TOWN OF ANDOVER
VT RTE 11, RURAL MINOR ARTERIAL
BRIDGE NO.: 41 PROJECT NO.: BHF 016-1(29)

PRESTRESSED SOLID SLAB LAYOUT

Vermont Agency of Transportation
RECEIVED
ON: June 10, 2015
and Checked for
CONFORMANCE
BY: D. PETERSON DATE: 06/11/2015

Andover BHF 016-1 (29) - Precast Beams Reviewed 06-10-15

DETAIL - "A"

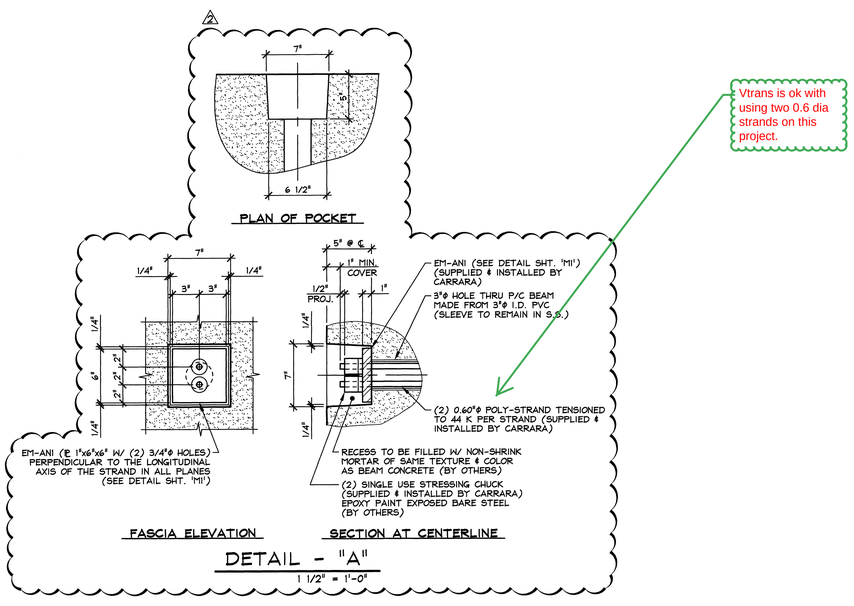
Vtrans is ok with using two 0.6 dia strands on this project.

1 SS2 DIMENSIONAL PLAN VIEW IN FORM
1/4" = 1'-0"

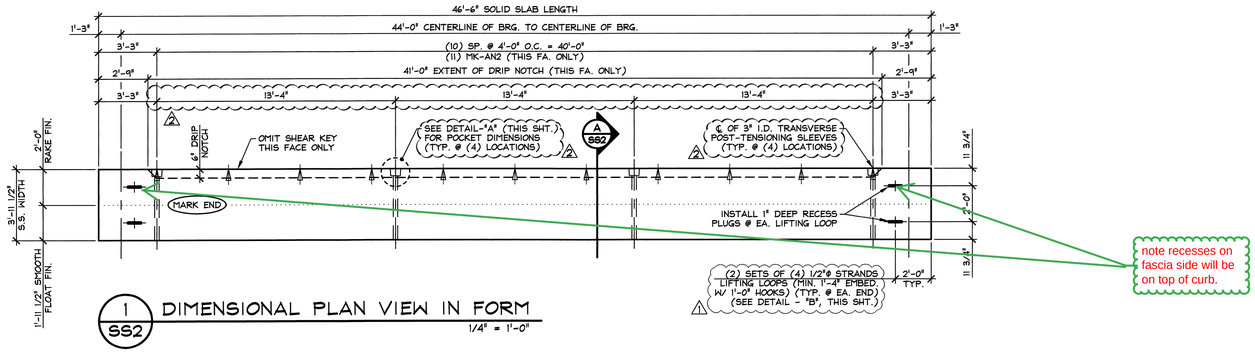
note recesses on fascia side will be on top of curb.
